## R.W. Gillespie & Associates, Inc.

Subject: Geotechnical Engineering Review of Gilman Street Temporary Support of  
Excavation Design  
Maine Medical Center Hospital Expansion  
Portland, Maine  
RWG&A Project No. 0557-031

## SECTION AT GILMAN ST LOOKING SOUTH TIEBACK 9 & 10

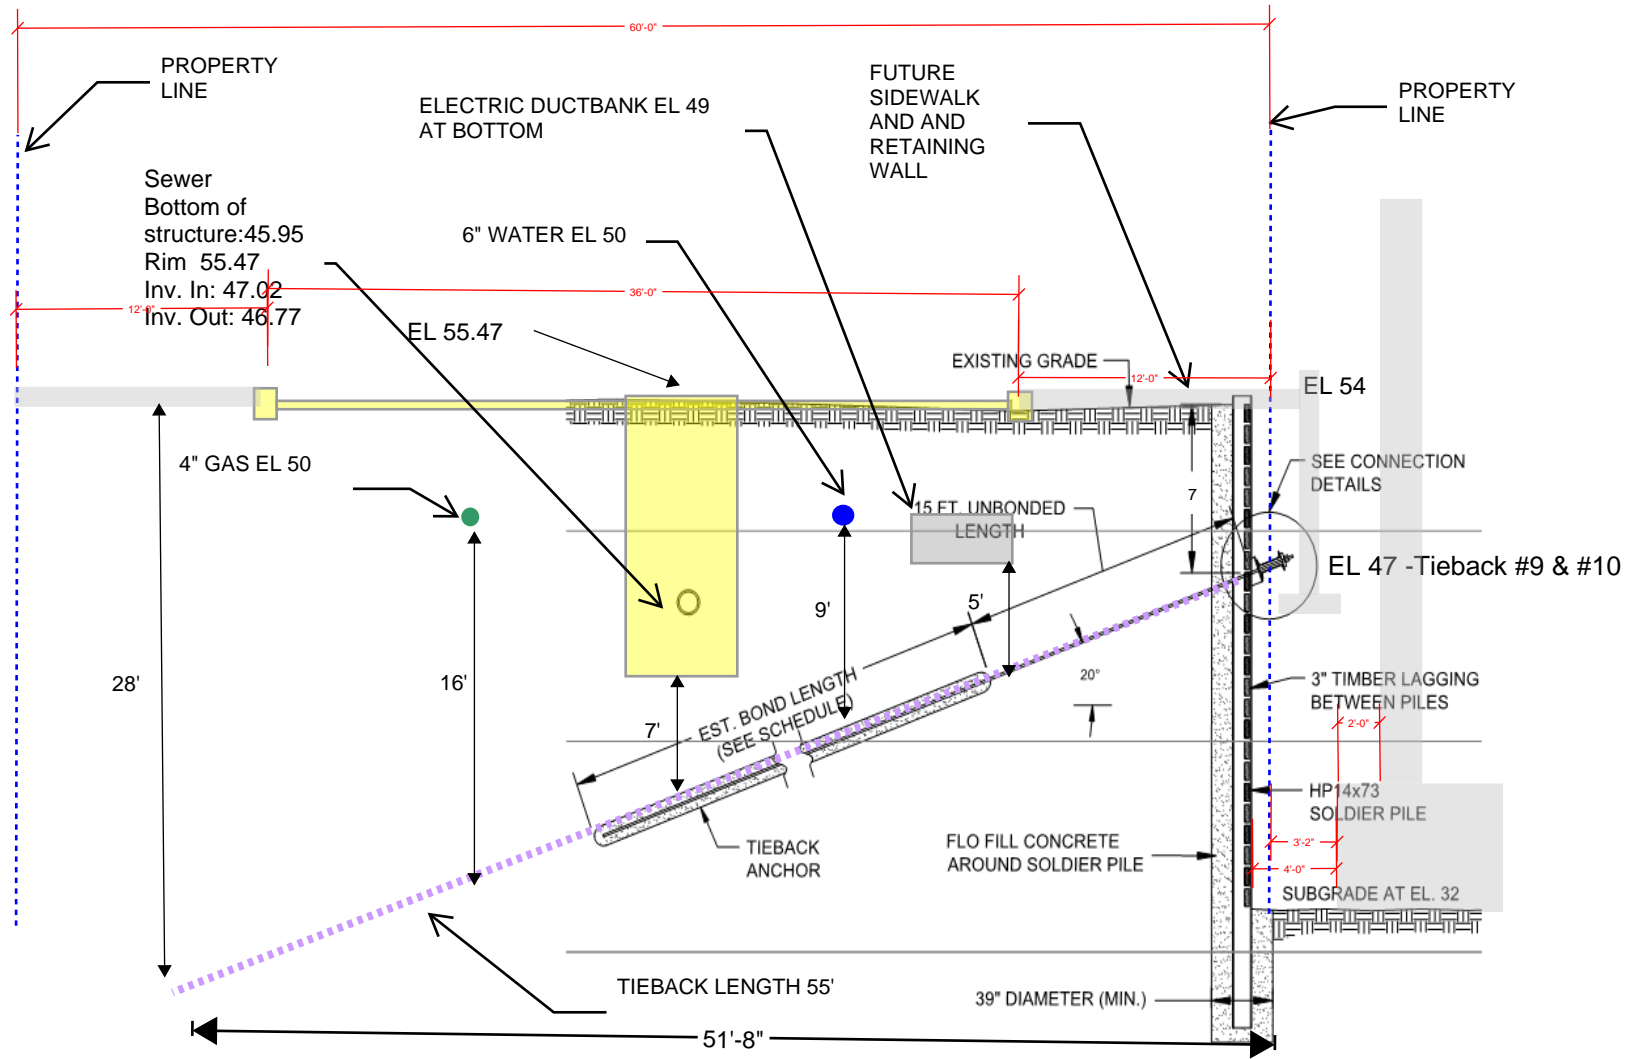
Based on the enclosed sketch titled *Section at Gilman St. Looking South Look South, Tieback 9 & 10*, the tiebacks would pass about 5 feet below an electrical duct bank, about 9 feet below a 6-inch waterline, about 5 to 7 feet below the bottom of SMH-8 and SMH-13533, and about 16 feet below a 4-inch natural gas pipeline at the west side of Gilman Street. The Contractor proposes to abandon four grouted soil tiebacks and four steel, H-shaped soldier piles in-place after the excavation between the SOE system and building foundation walls is backfilled. The H-piles are about 24 inches square in plan dimensions and would be surrounded by "flo fill" which we understand is a low-strength concrete. The sketch indicates that the "flo fill" and soldier piles would be removed to a depth 6 feet below the final grade after completion of foundation work.

Anchor Tieback Limits: The sketch prepared by Turner indicates that the Gilman Street right-of-way is 60 feet wide. The design calls tieback 65 feet long installed at a 20-degree downward angle. Based on the length and angle, the tiebacks would extend a horizontal distance of about 61 feet. It appears from the wale-to-pile connection detail that about 1 foot of the tieback would be located on the project side of the boundary, which would locate the end of the tieback very close to the Gilman Street westerly right-of-way boundary. If there are deviations from the design tieback lengths and inclinations, or in soldier pile positions, it is conceivable that the tieback might extend outside of the right-of-way and into the abutter's property.

*MMC should affirm that survey, construction, and design modifications are in place to assure that the tieback system will not extend beyond the westerly right-of-way boundary. The contractor should indicate how location, length, and angle control will be maintained and verified during installation.*
